Service Bulletin

Bulletin No.: 20-NA-198

Subject: Trailer Running Lights Shut Off Due to Excessive Load on the Running Lamp Circuit

5652571

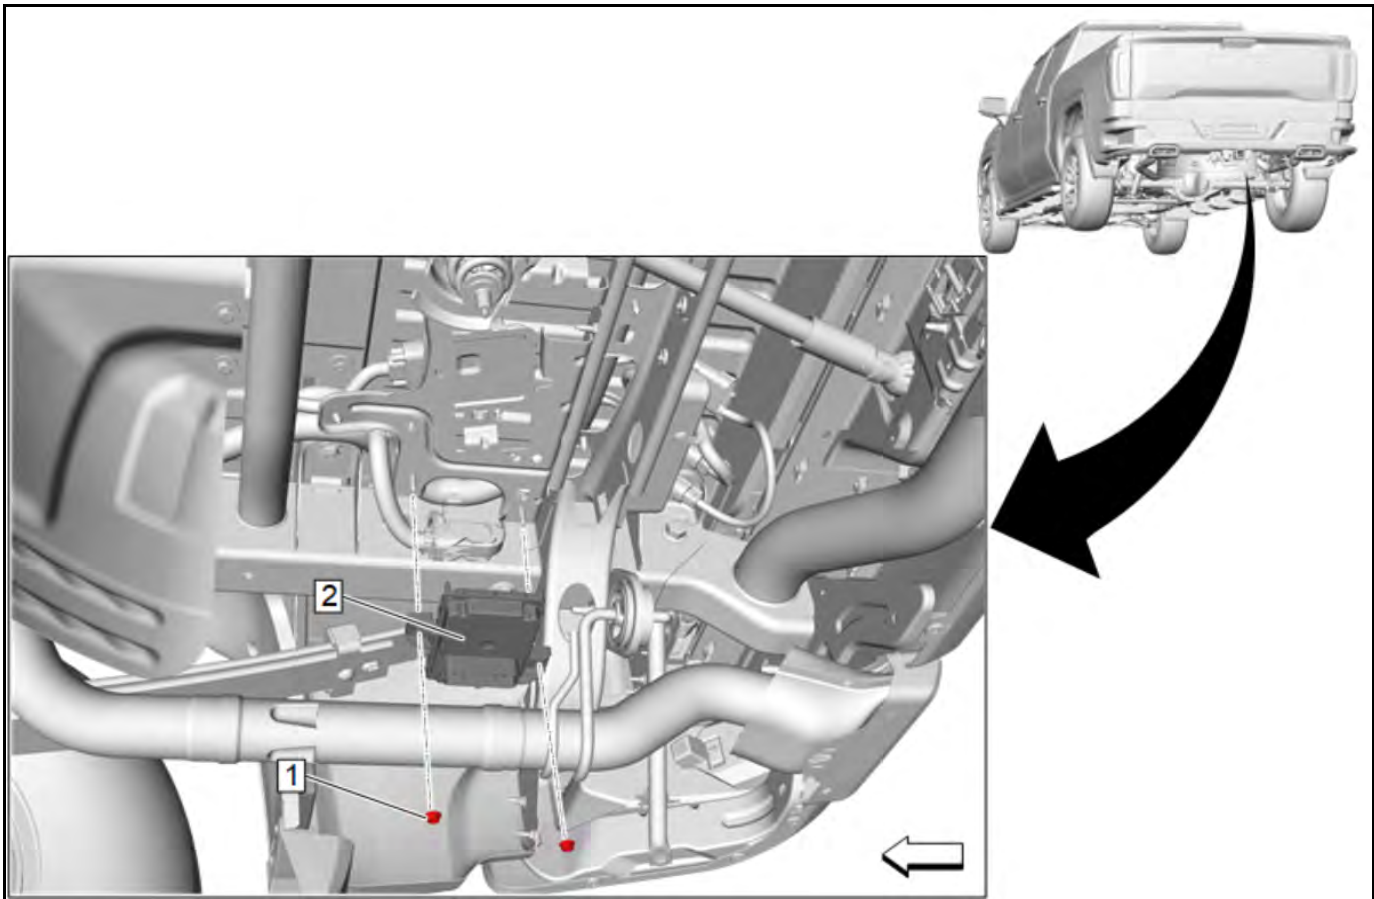
For 2019 models ONLY, Follow the steps in the Service Procedure below, and move circuit 2109 on the Trailer Lamp Control Module from X1 cavity 5 to X1 cavity 25, and load new software from SPS into the Trailer Lamp Control Module.

5209978

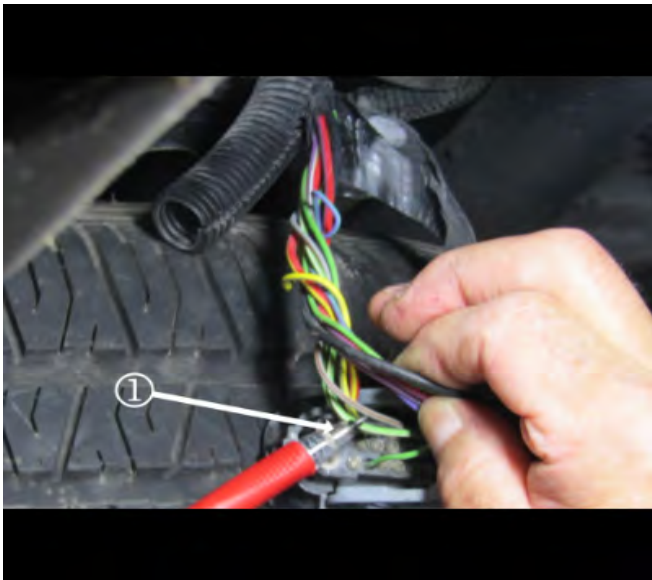
3. Locate the Trailer Lamp Control Module (2) and disconnect the chassis harness X1 electrical connector.

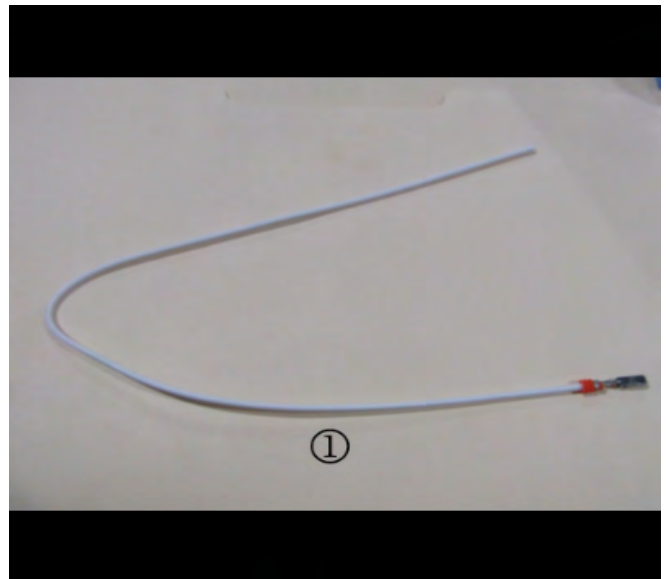
6. Locate the Gray/Brown wire, at pointer (1), connected to cavity 5, and cut the wire approximately 7.62 cm (3.0 in) from the connector body. The wire will be re-located to cavity 25 (2).

5662018

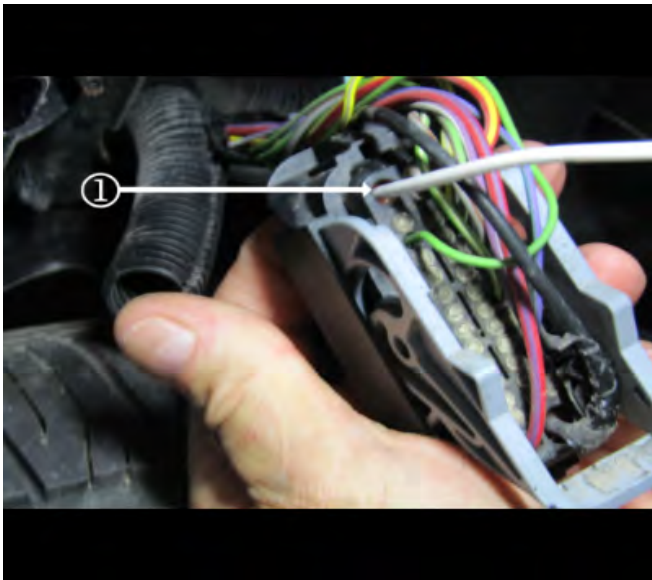
7. Release the 4 tabs on the Terminal Position Assurance (TPA) and pull slightly upward to partially release it from the connector housing.
